**RAI 03.07.01-27, Supplement 1, Revision 1**

**Follow-up Question to RAI 03.07.01-19 (STP-NRC-100093)**

**REVISED SUPPLEMENTAL RESPONSE:**

**RAI 03.07.01-27, Supplement 2, Revision 1**

**Figure 03.07.01-27.19 - 5% Damped Spectral Comparison in Vertical Direction at Top of Roof Slab (Corner away from access room), El. 30.0 ft**

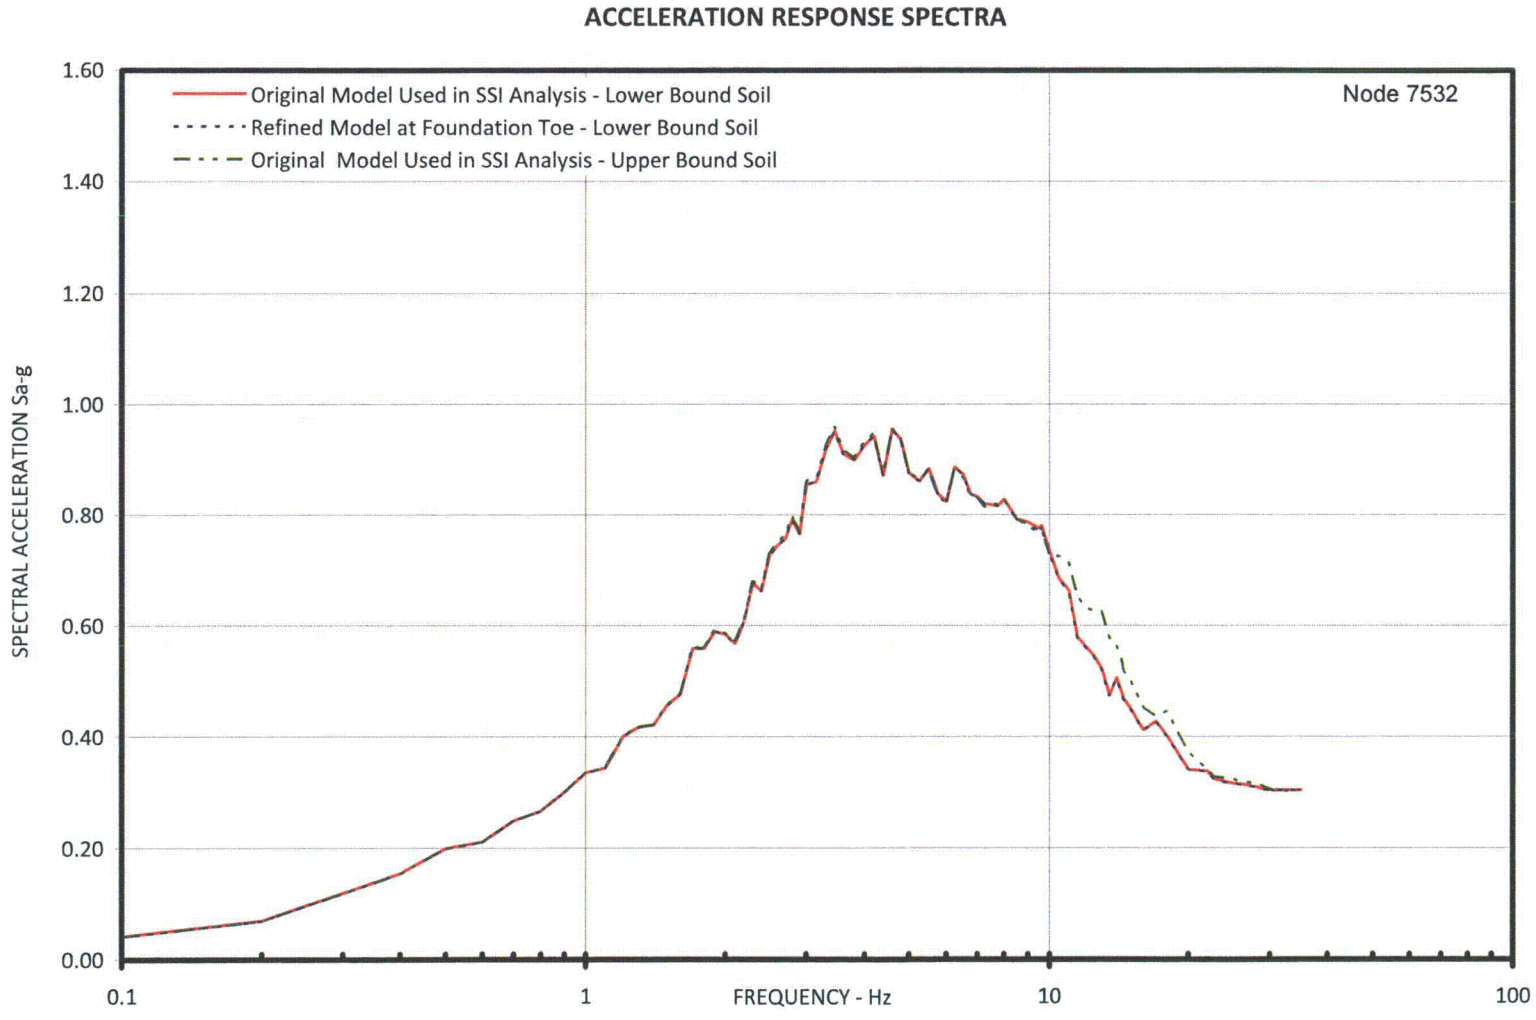
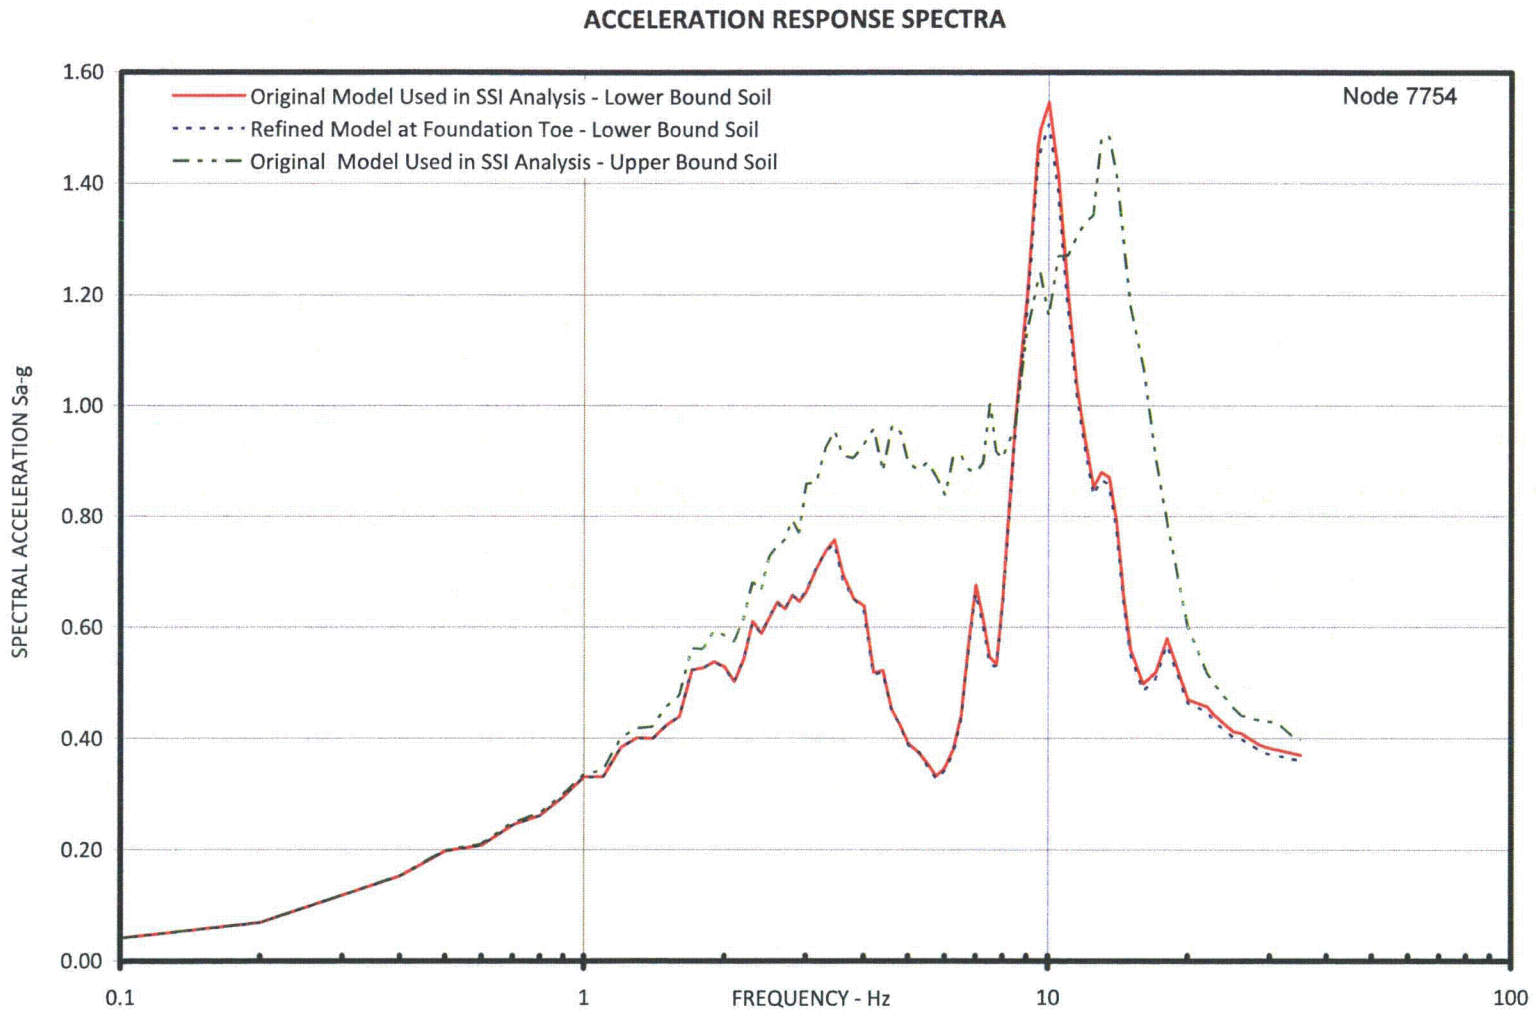
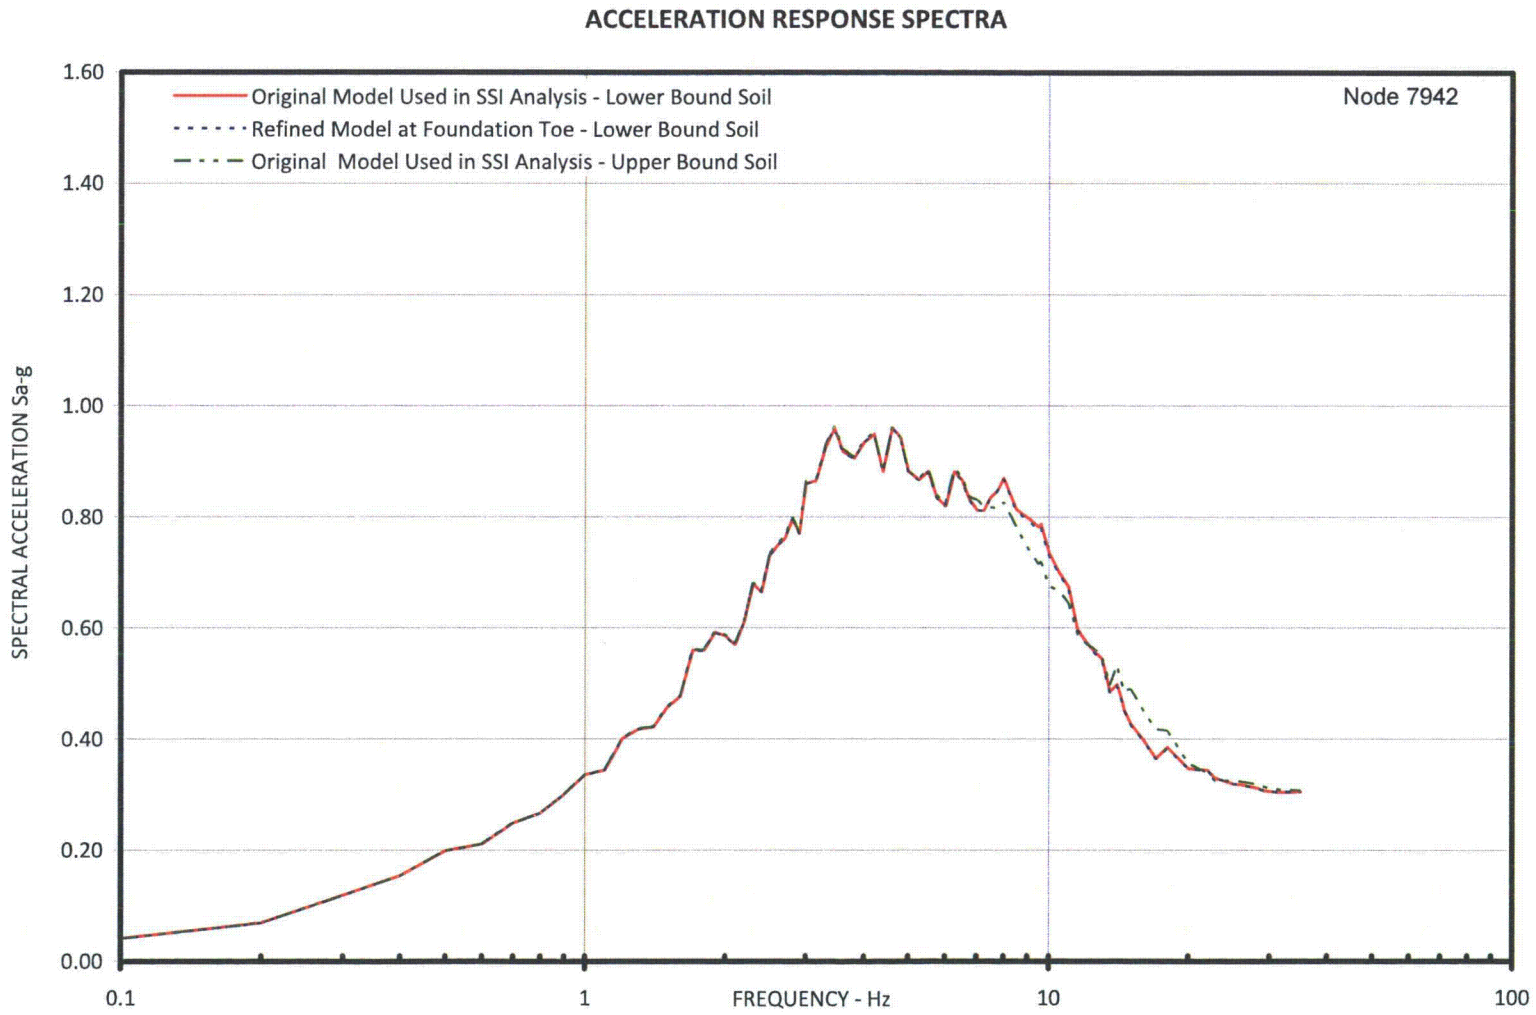
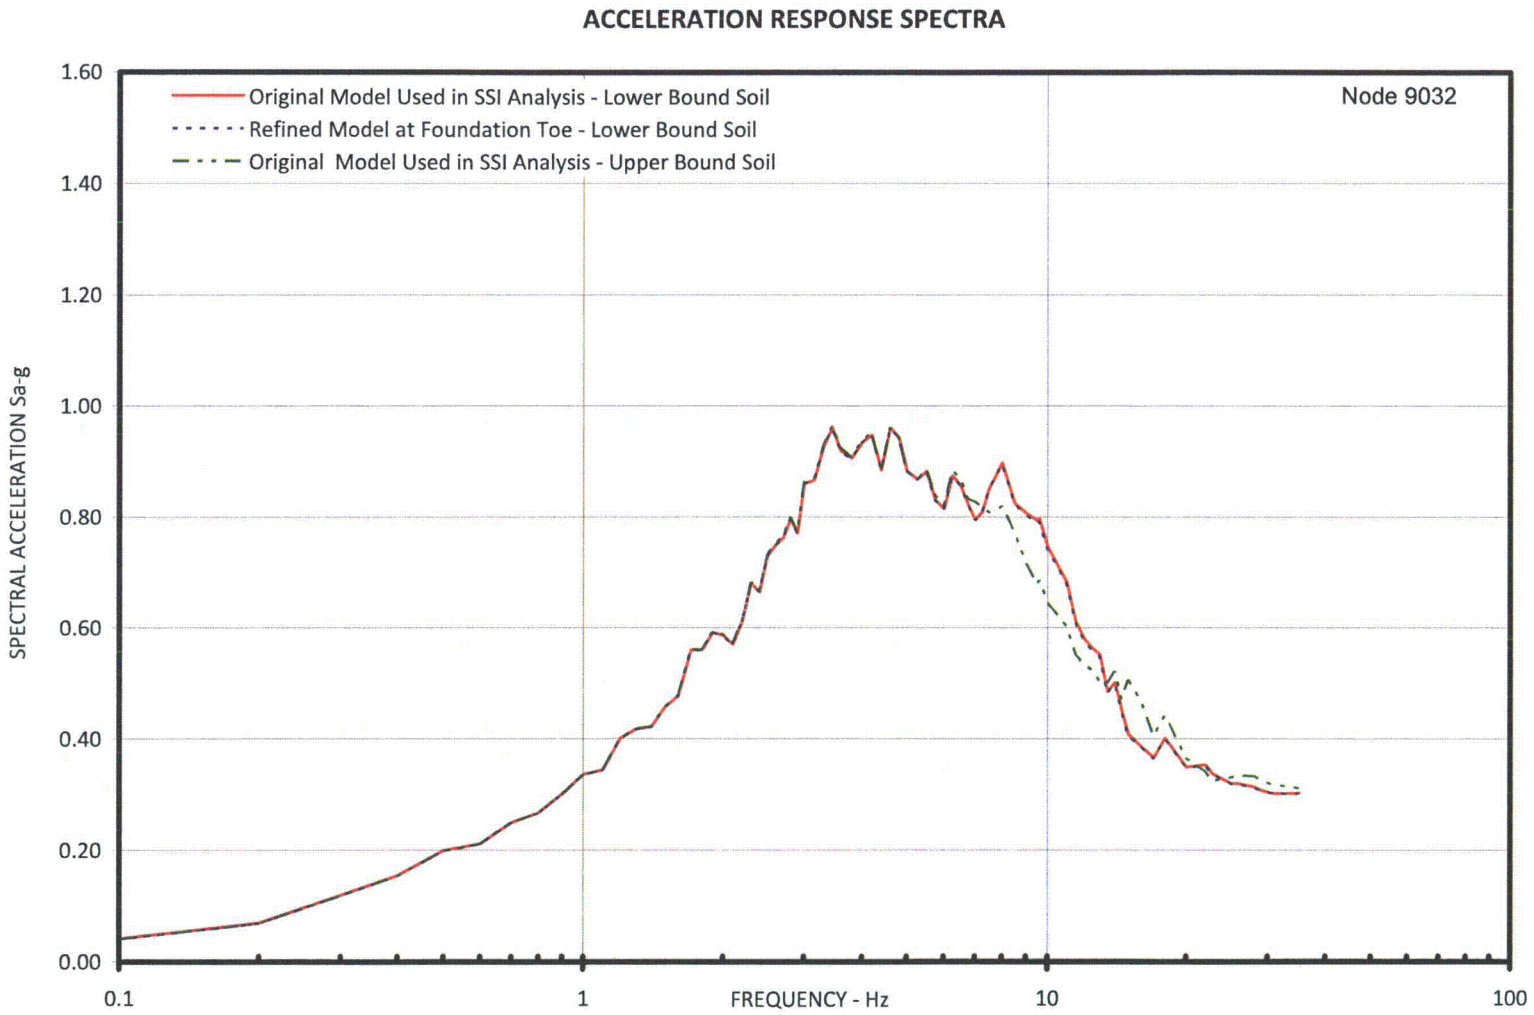
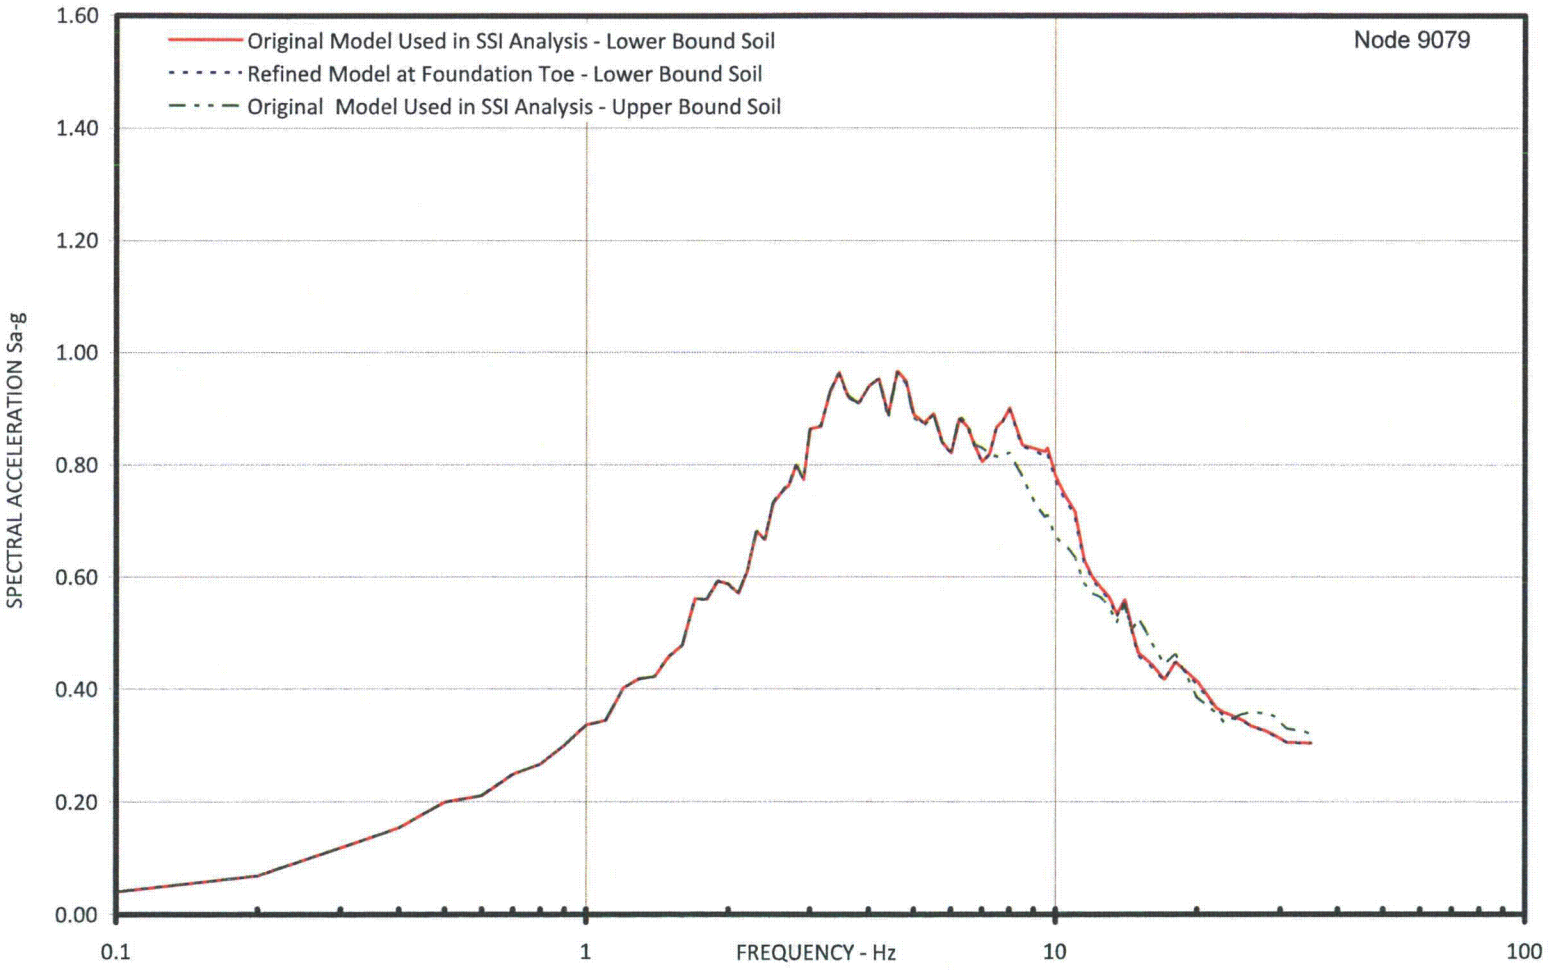
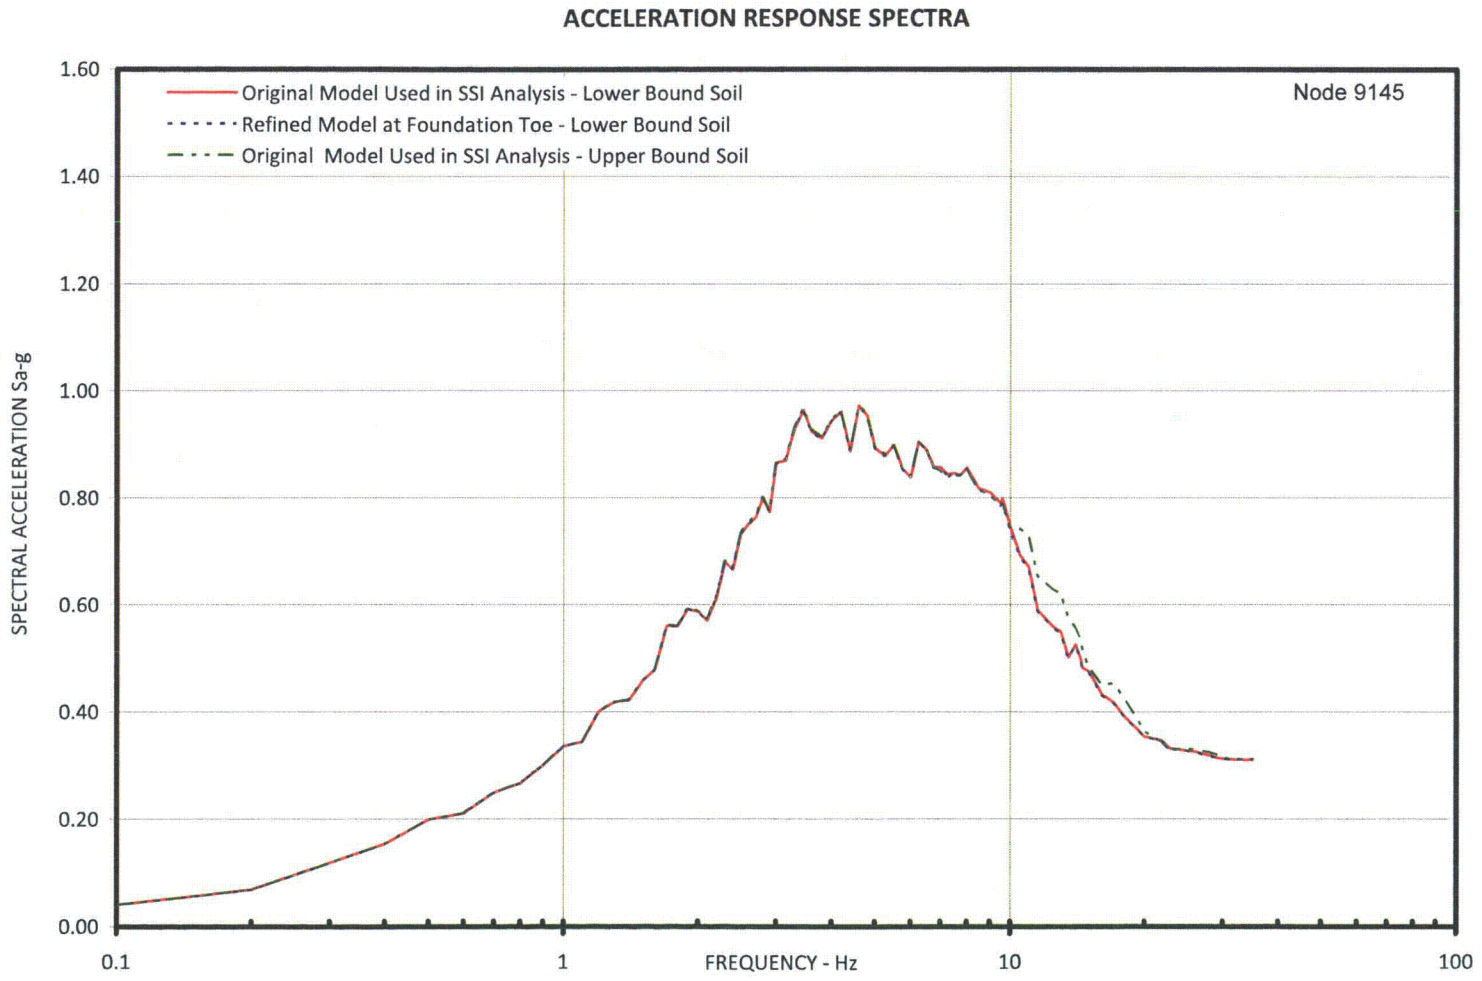
1. 10CFR50, Appendix S requires that evaluation for SSE must take into account soil-structure interaction (SSI) effects and the expected duration of vibratory motion. In the response to the first paragraph of RAI 03.07.01-19, the applicant has presented its approach for developing the input motion for the SSI analysis and design of the DGFOSV that takes into account the impact of the nearby heavy RB and RSW Pump House structures. The applicant also stated that *"Conservatively, a 3-dimensional SAP2000 response spectrum analysis was used to obtain the safe-shutdown earthquake (SSE) design forces due to structure inertia. The seismic induced dynamic soil pressure on DGFOSV walls were computed using the method of ASCE 4-98, Subsection 3.5.3.2"* The response, however, does not provide details as to how the SSI analysis of the DGFOSV are performed and how the input motion developed are subsequently specified in the SSI analysis of DGFOSV to develop the structural response and in-structure response spectra for any equipment and subsystems within DGFOSV. From the response it appears that the applicant has not included explicitly DGFOSV structural model in the SASSI model of the RB and RSW Pump House structures to properly evaluate the SSSI effect on the DGFOSV. In order for the staff to determine if the evaluation of DGFOSV for SSE has appropriately accounted SSI effects, the applicant is requested to provide in the FSAR the following information:

To evaluate the effect of 20 Hz passing frequency for LB in-situ case, the foundation toe was divided into two elements, thus increasing the passing frequency to 40 Hz. This refined model with LB in-situ soil properties was analyzed and 5% damped spectra from this model were compared with the spectra from the original model with passing frequency of 20 Hz. The spectra comparison plots are shown in Figures 03.07.01-27.1 through 03.07.01-27.24. The comparison shows that:

- In the X direction, there is insignificant difference between the response spectra from the two models
- In the Y direction, the response spectra from the two models matched well except at frequency of about 3.8 Hz where the refined model produced higher spectra.

However, spectra from both the models are enveloped by the spectra for UB in-situ soil case

- In the vertical direction, the spectra from the two models matched well (insignificant difference)

Based on the above evaluation it is concluded that the horizontal direction passing frequencies are acceptable.
